SCHULTE COUNTRY STORAGE ADDITION

RE: SUB 2001-06 -- Final Plat of Schulte County Storage Addition

RE: SUB 2002-06 -- Final Plat of Schulte County Storage Addition

CASE NUMBER: SUB 2001-06 -- SCHULTE COUNTRY STORAGE ADDITION

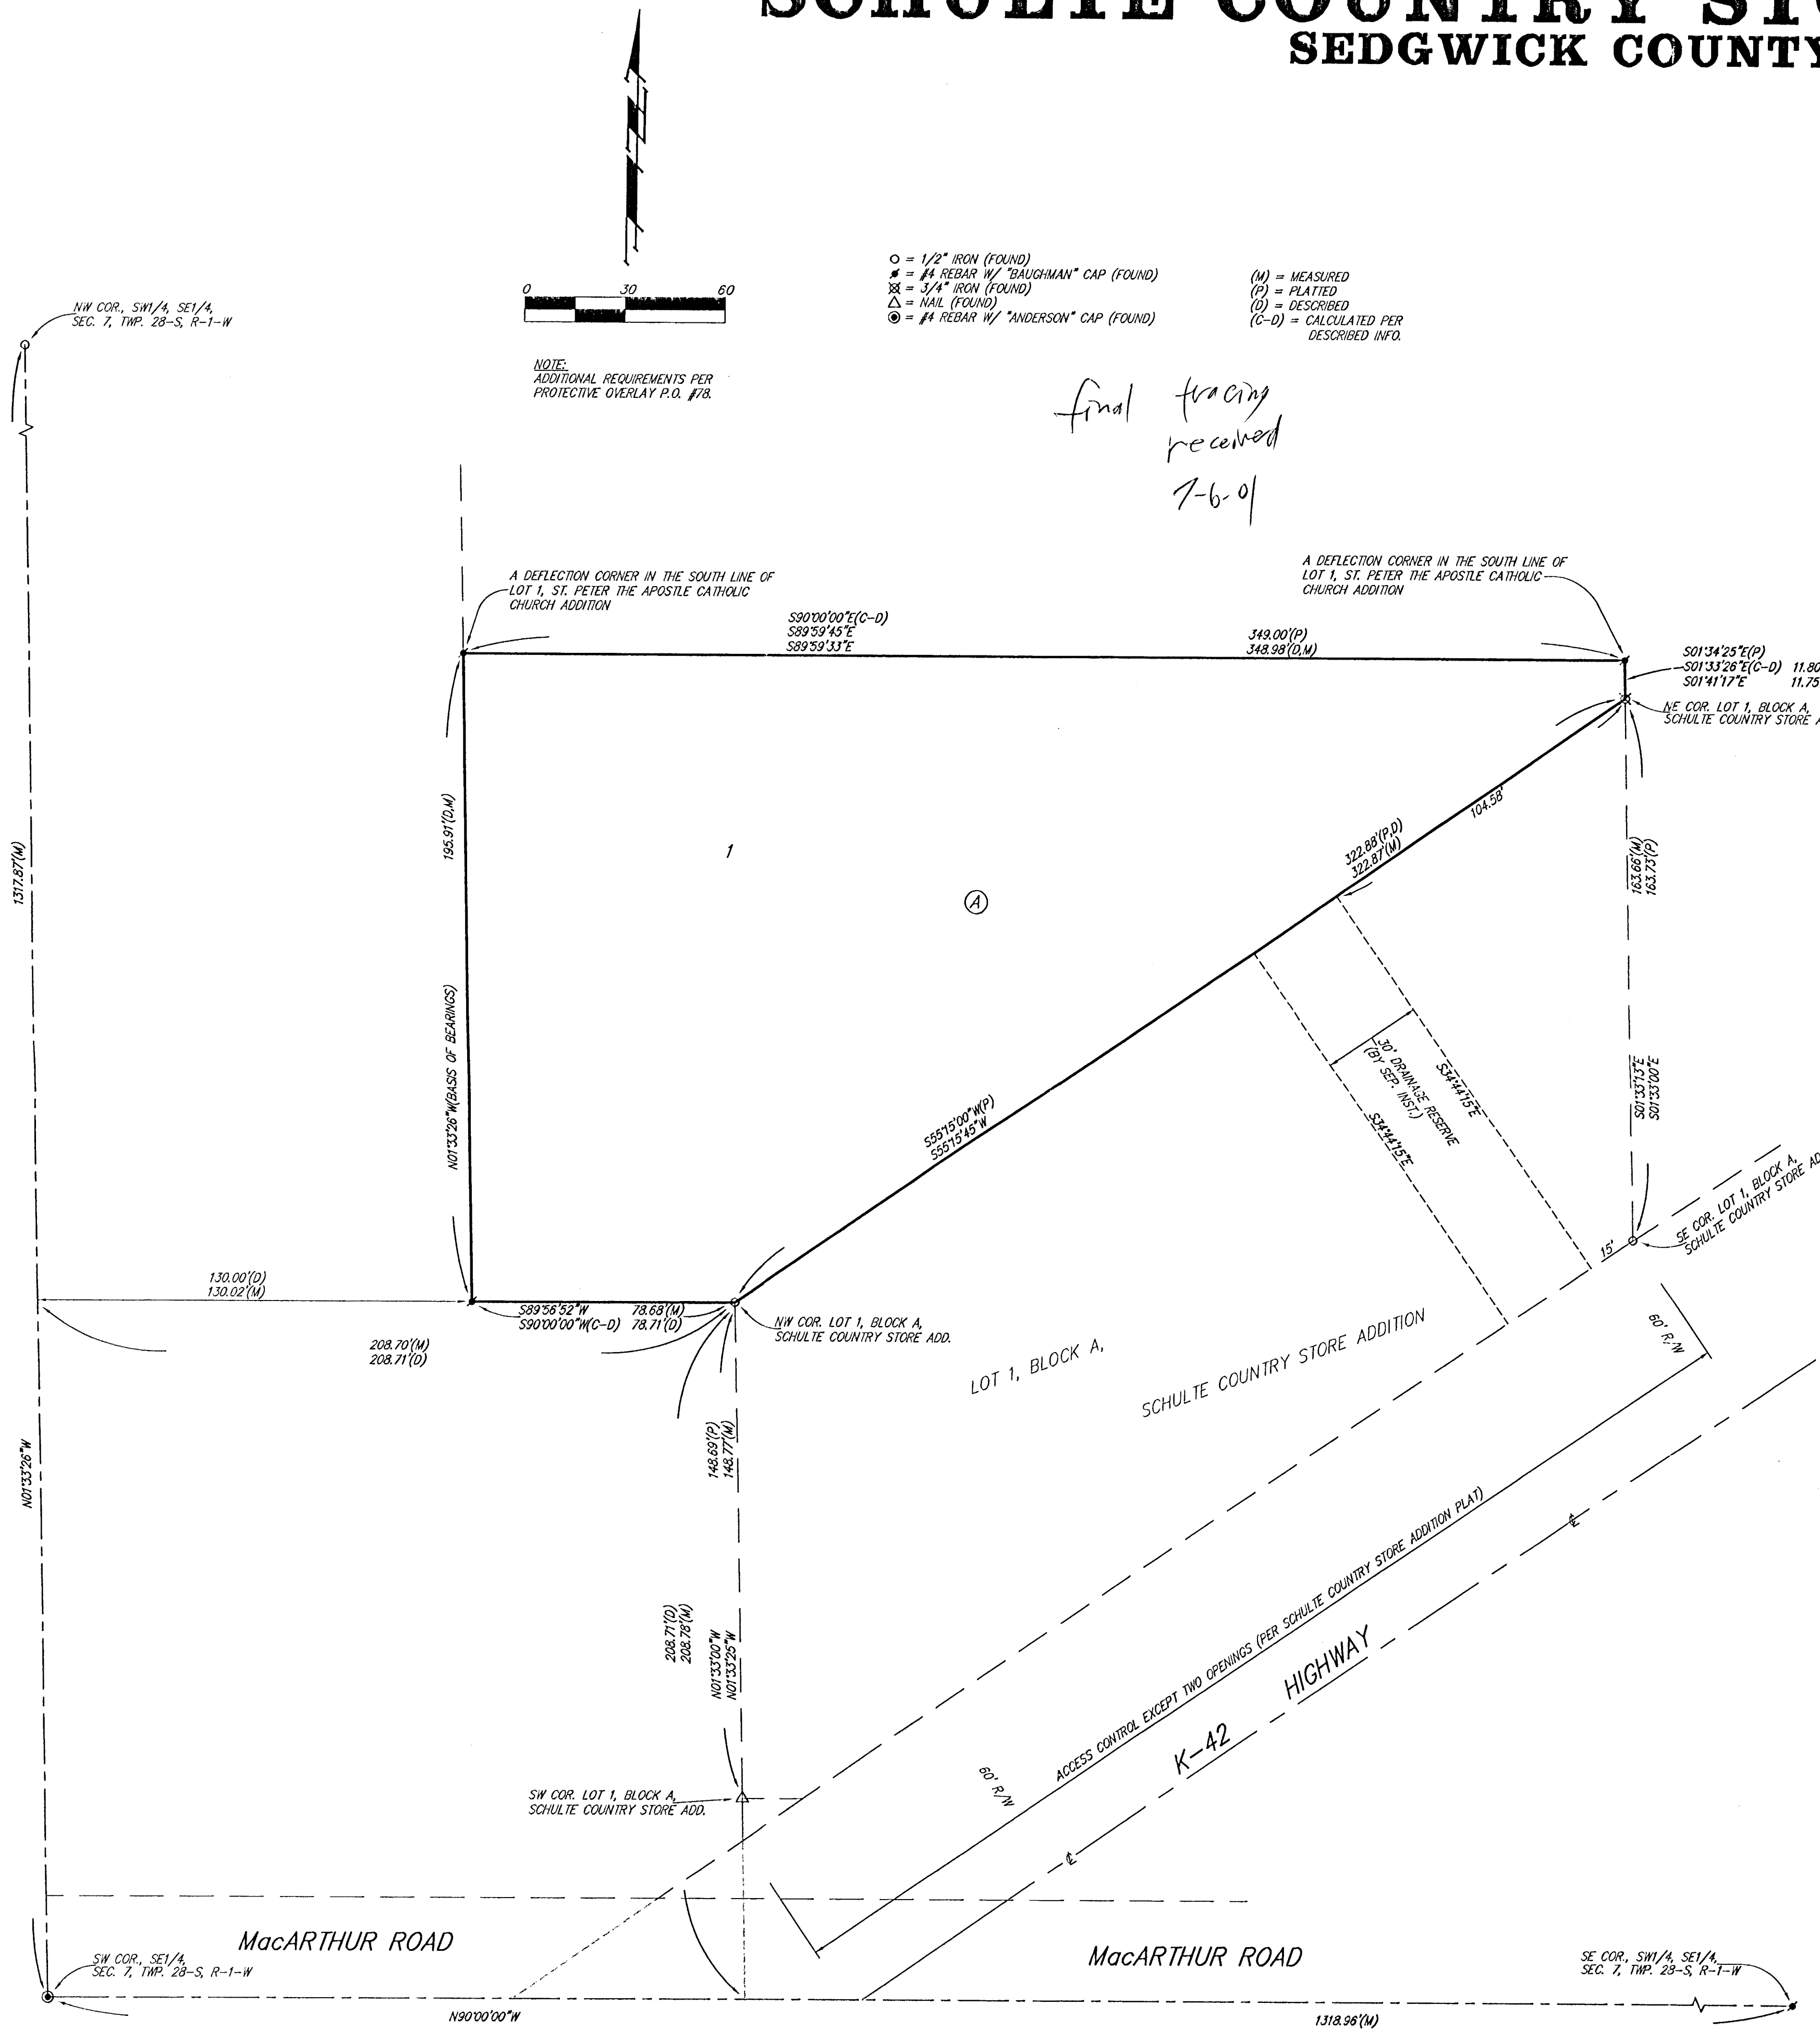
- D. **County Engineering** needs to comment on the status of the applicant's drainage plan. *A floodway reserve is needed across Lot 1, Block A, Schulte Country Store Addition. and should be established by separate instrument. A letter shall be provided from KDOT indicating their agreement to accept drainage occurring onto K-42.*

- E. Access to this site is proposed from K-42, through an existing driveway located on the adjoining property to the southeast. A cross-lot access agreement will need to be granted by separate instrument. *The face of the plat shall indicate, "Access control except two openings as shown on Schulte Country Storage Addition." County Fire Department has required construction of the access drive prior to any structures.*

- I. On the final plat, the MAPC signature block needs to reference "J.D. Michaelis, Acting Chair".
- J. The platlor's text shall include language that a drainage plan has been developed for the plat and that all drainage easements, rights-of-way, or reserves shall remain at established grades or as modified with the approval of the applicable City or County Engineer, and unobstructed to allow for the conveyance of stormwater.

- D. County Engineering needs to comment on the status of the applicant's drainage plan. *A floodway reserve is needed across Lot 1, Block A, Schulte Country Store Addition, and should be established by separate instrument. A letter shall be provided from KDOT indicating their agreement to accept drainage occurring onto K-42.*

- E. Access to this site is proposed from K-42, through an existing driveway located on the adjoining property to the southeast. A cross-lot access agreement will need to be granted by separate instrument. *The face of the plat shall indicate, "Access control except two openings as shown on Schulte Country Storage Addition." County Fire Department has required construction of the access drive prior to any structures.*

- I. On the final plat, the MAPC signature block needs to reference "J.D. Michaelis, Acting Chair".
- J. The plat's text shall include language that a drainage plan has been developed for the plat and that all drainage easements, rights-of-way, or reserves shall remain at established grades or as modified with the approval of the applicable City or County Engineer, and unobstructed to allow for the conveyance of stormwater.
